SPIRE

Technical Note

Bolometer Wiring
J. Delderfield

Ref: SPIRE-RAL-NOT-
000565

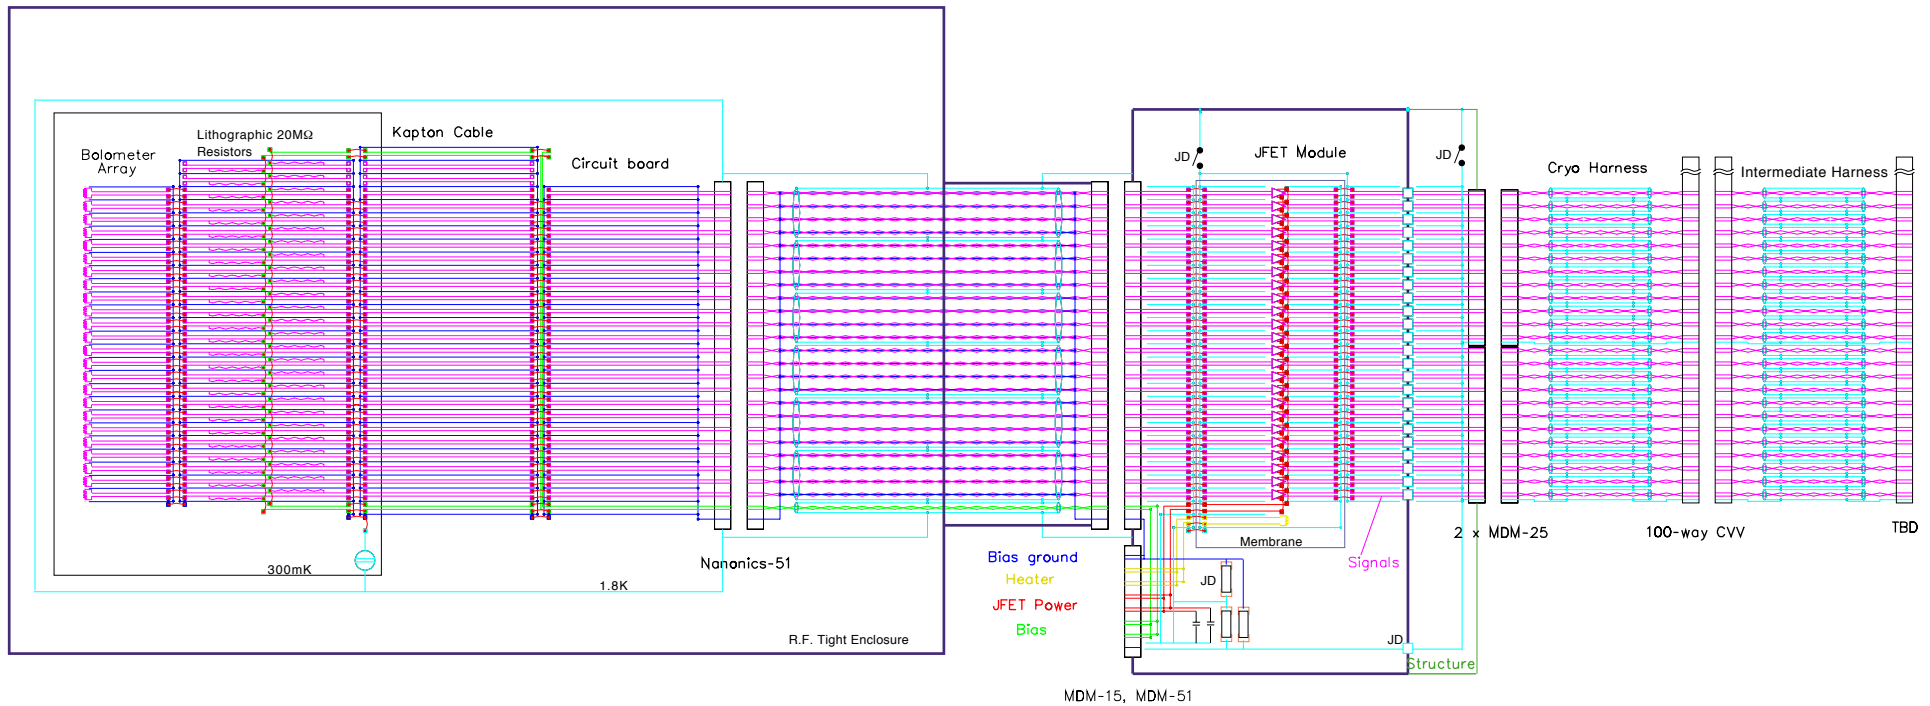
On Friday we got the wiring diagram you sent opened at long last and hence understood. It shows masses of useful detail and unpacks to >32,000 elements! I've reproduced it above but taken the liberty of shortening some of the twisted wires to make the file a little shorter, and also added some section boxes, etc. as described below.

1. The 51 Nanonics have 48 contacts for 24 twisted signals, 2 contacts for the biases and one ground pin. This is an encouraging start because it's the same as I drew! I believe there's a link via a mounting screw on the Lithographic Resistor module from said ground to the 300mK chassis...please confirm. However, if the 300mK is hung on Kevlar string and not electrically joined to the 1.8K BDA body, I think that near the "1.8K" label on the diagram there should be a link on the BDA's "circuit board" joining this same ground to BDA 1.8K chassis, i.e. just inside the Nanonics connector.

5. The FPU's R.F. Tight Enclosure on the above is drawn on by myself. There are back-to-back connectors baselined at the point where this harness transits said wall at 12K. These should be included in your diagram until it is clear that they may be removed. The harness certainly needs heatsinking at this interface. Also, the JFET module's r.f. filtered volume has to be rigorously extended back to the FPU for the outer part of this cable run, so I have taken the liberty of drawing a couple of lines on your drawing. Just by way of comment, these terminate on a connector body...I note some light blue lines seemingly bridging connector I/Fs on the above!

7. The JFET module as drawn seems to omit the 12Kelvin 100Ohm drain resistors drawn on other JPL circuits and any power supply decoupling / cold FET gate resistors as drawn in some documents. Please comment.

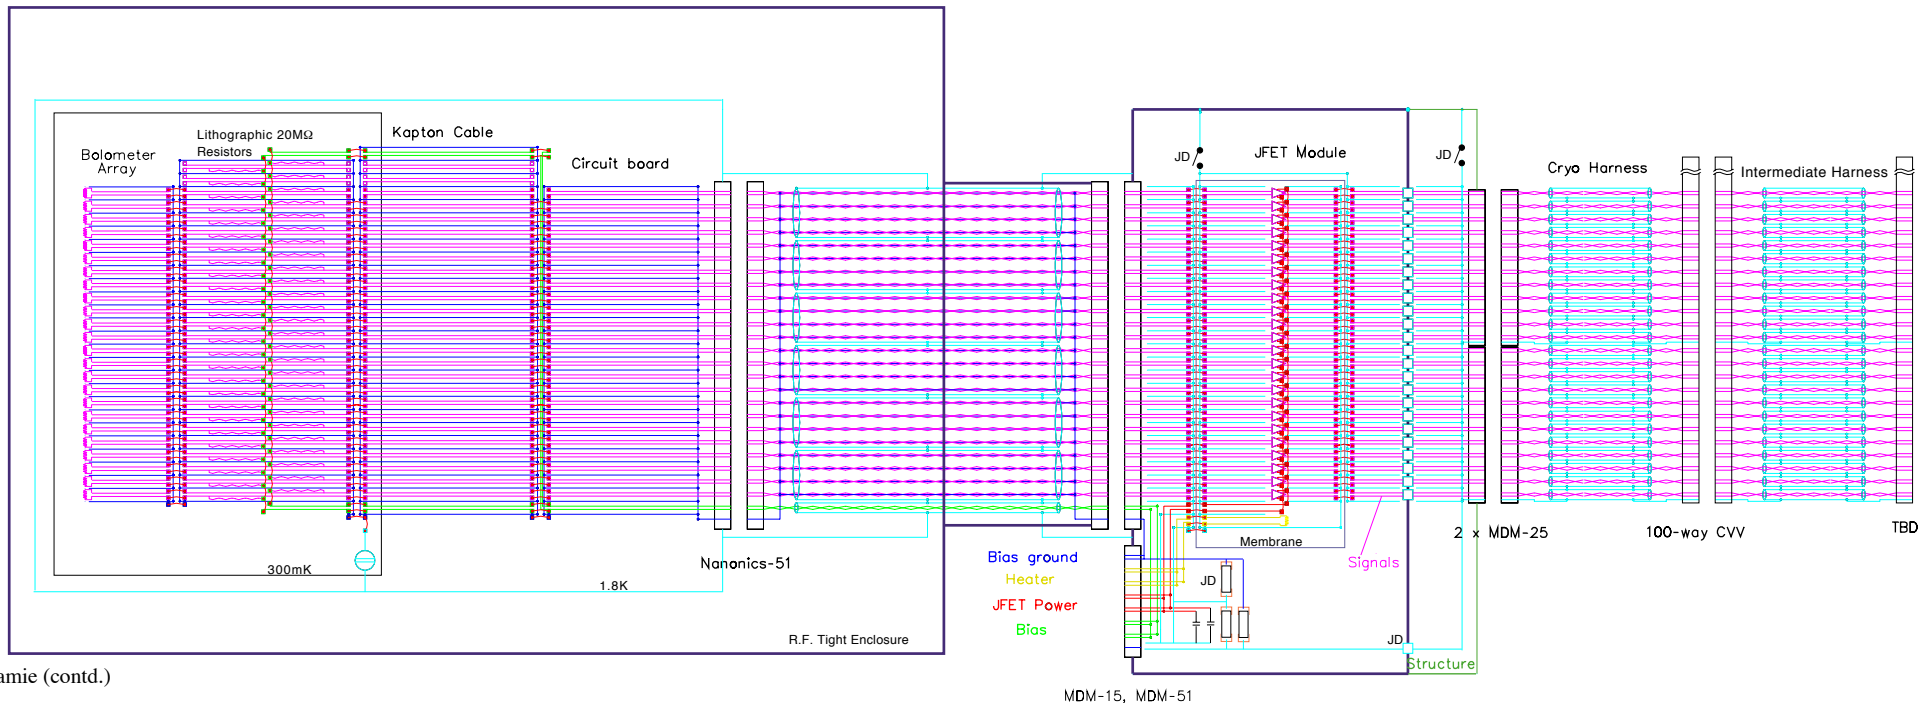
2. Going right to the other end of the system, we both have JFET signal outputs on 2x25W MDMs going towards the warm electronics each with 24 contacts for 12 twisted signals and one ground pin. We differ as to how these are then harnessed. I don't think ESA would want to use a screened twisted pair for every channel as you have drawn, so I have suggested a cable lay-up that differs from this, shown for on 100 way and hence two JFET module outputs as follows:

48 channels (each +, - and signal ground) as twisted triples, grouped as four triples in a "12-ax" with an insulated screen. So there are three 12-ax to each 25 way changing to four for each 50way connector on the warm electronics.

All of the signal grounds in the triples pass through the 50 way connectors, but only 4 can pass through the 100 ways, the rest being NC in the intermediate harness at that point. The four that pass shall correspond to the 4 single grounds that also pass through the 25 way connectors. A wire ring shall be supported on each side of the 100 way on the 4 ground contacts that pass through it. The signal grounds in triples in the cryo harness that do not have contacts on the 25 way connectors shall be made-off on one of these rings but NC at the JFET end.

The "12-ax" screens all pass the 50 ways on pins, are made off on the rings at the 100 ways, and are spliced (by tails) on to the ground pins in the 25 ways.

All of this harness is enclosed in outer r.f. screen, EMC sealed to connector boots, overwrapped with double-wound insulation, shown as brown dashed line.

This links to a defined set of pins on Christophe's DCU which I will not repeat here. I think the capacitance of my suggestion should be lower, there's considerably less metal used as screens, and I have kept the signal grounds separate from r.f. screens. If you have any misgivings about my suggestion, please raise them, otherwise it would be simplest to keep it as-is since ESA already have this information.
